Access Compliance Report Public Rights-of-Way (Curb Ramps)

Main Street: RED_HILL_AVE Cross Street: BULLARD_RD Location: E

ADA ID: RPRK211014175946 Ramp Type: Type 1 - Perpendicular Diagonal Initial Pass/Fail: Pass Overall Compliance: No Severity Score: 4

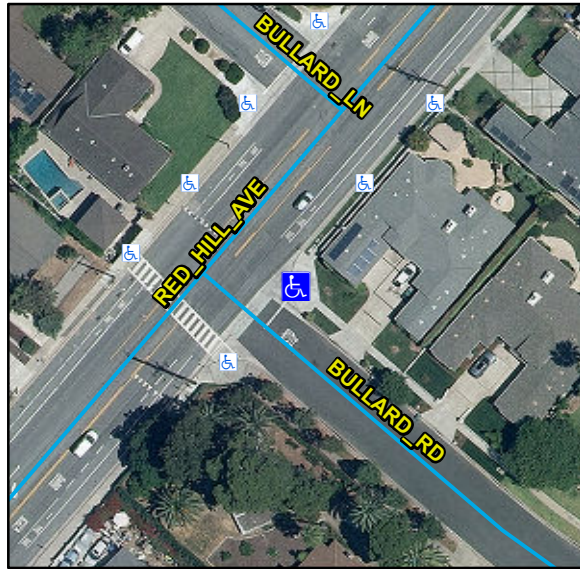
R304.2.2, R304.2.1, R304.2.2-Perp, R304.3.2-Para, STD 1115

Remove & Replace Curb Ramp With Two New Directional Ramps or Equivalent.
